INTER-DEPARTMENTAL REVIEW COMMITTEE REPORT

543 E. TAYLOR ROAD (FORMER FAIRWOOD SCHOOL)

February 6, 2017

PC 17-03

TITLE:
Estimated Directional Distribution

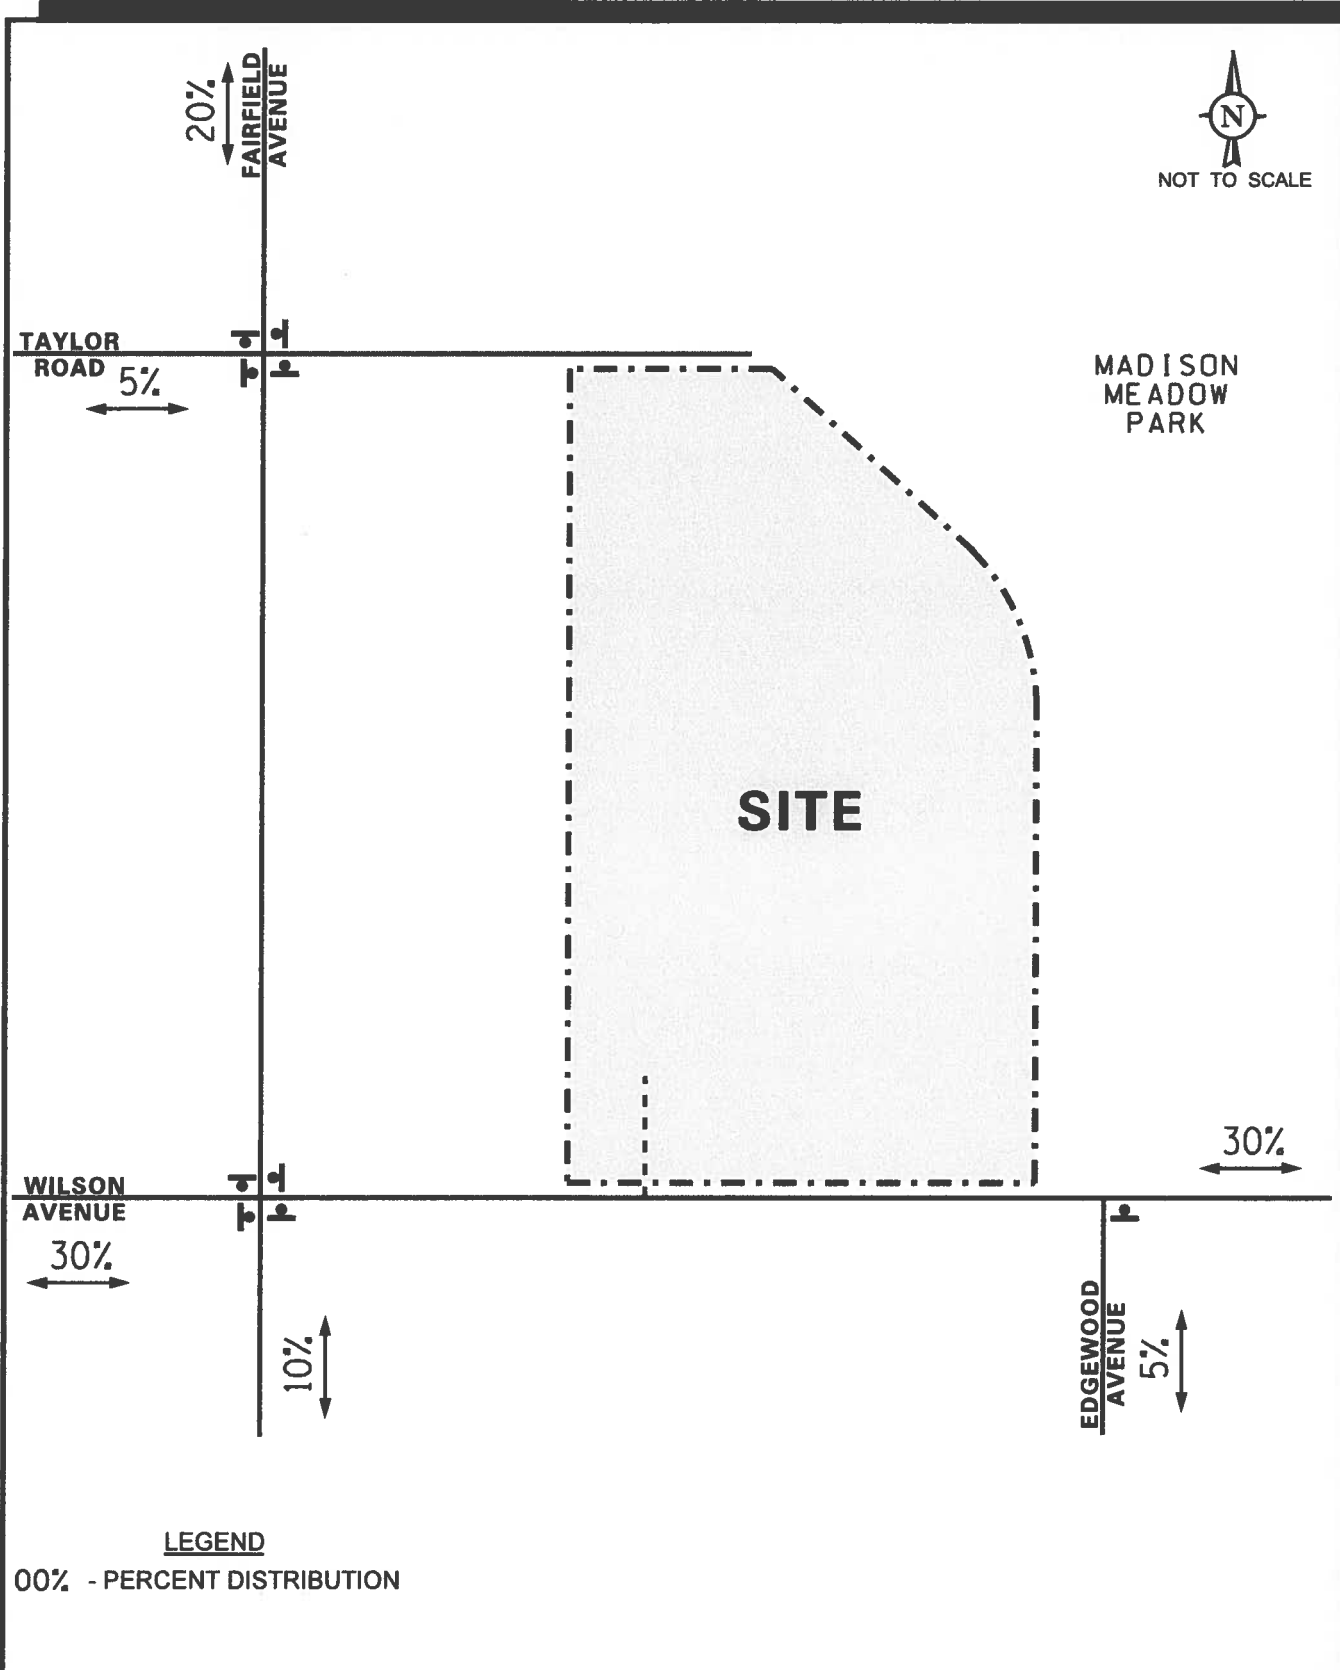
The estimated weekday morning, evening and Saturday midday peak hour traffic volumes that will be generated by the proposed development were assigned to the roadway system in accordance with the previously described directional distribution (Figure 4). **Figure 5** illustrates the vehicular traffic assignment.

PROPOSED SITE

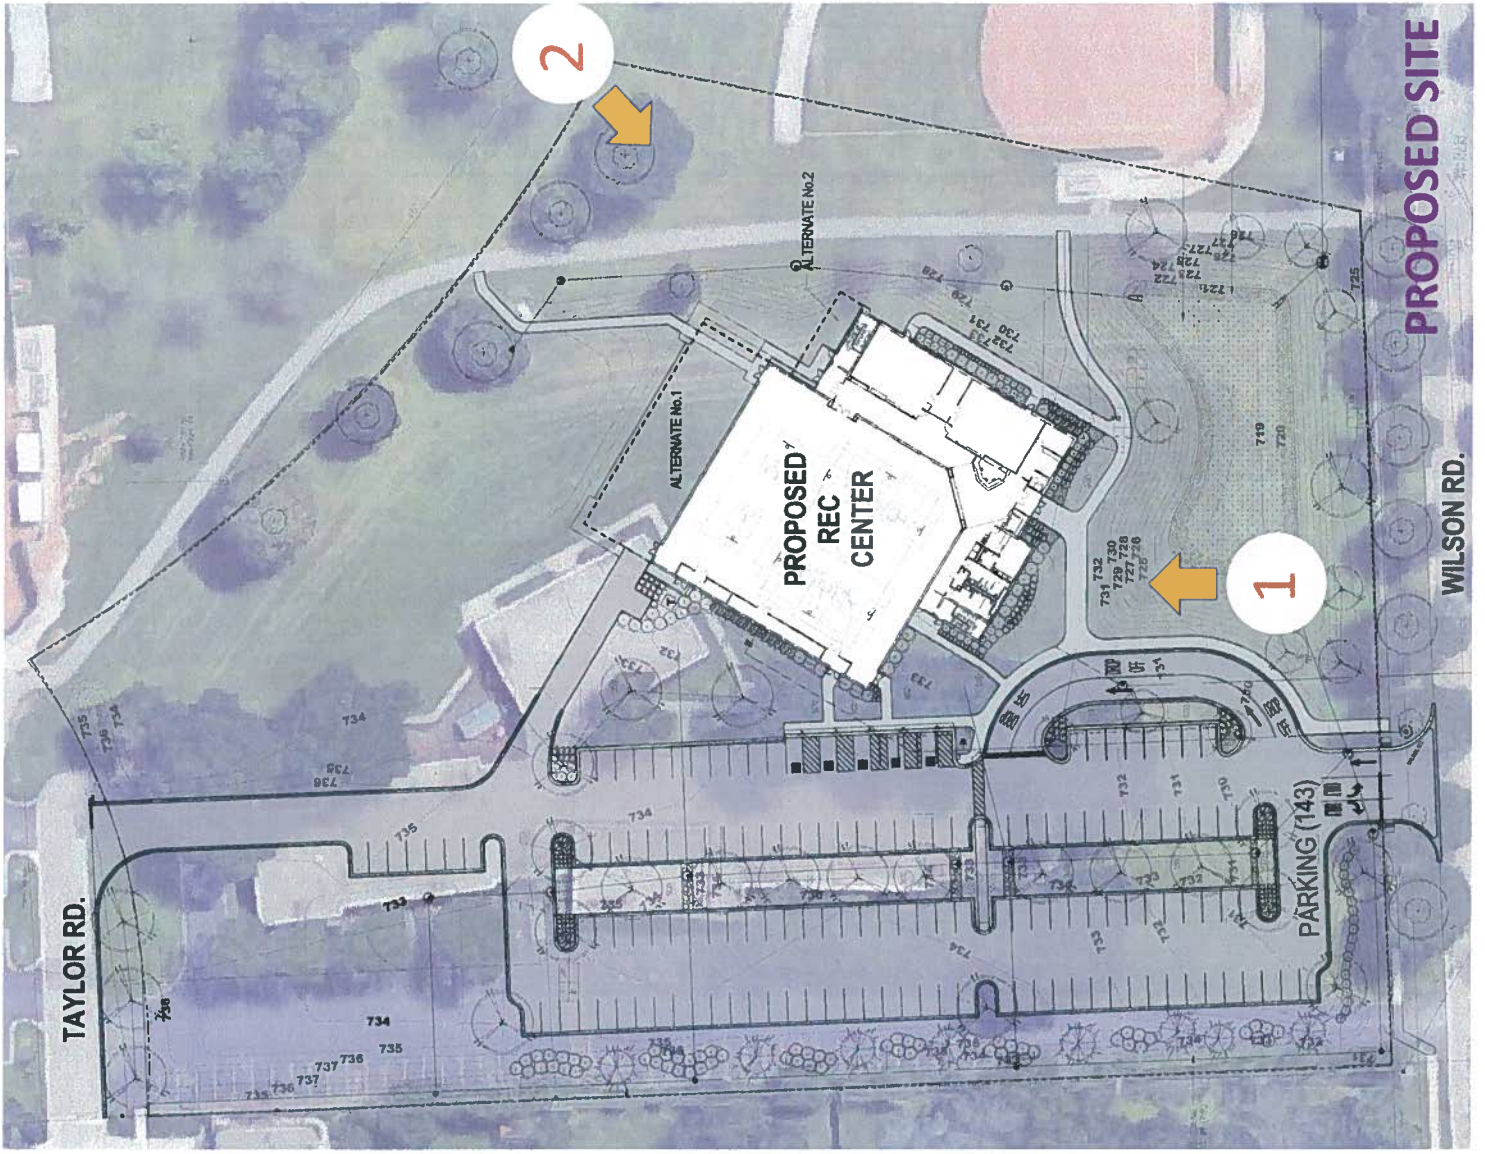
1. The proposed location of the drop-off lanes on Sheet C-1.0.2 should be studied to determine the impact of vehicles backing up onto Wilson Avenue during peak drop off times. Parents will likely idle/park there until their kids exit en masse from games, coinciding with parents dropping off kids for the next games. At a minimum it is suggested that these lanes be posted as a "no standing" zone.
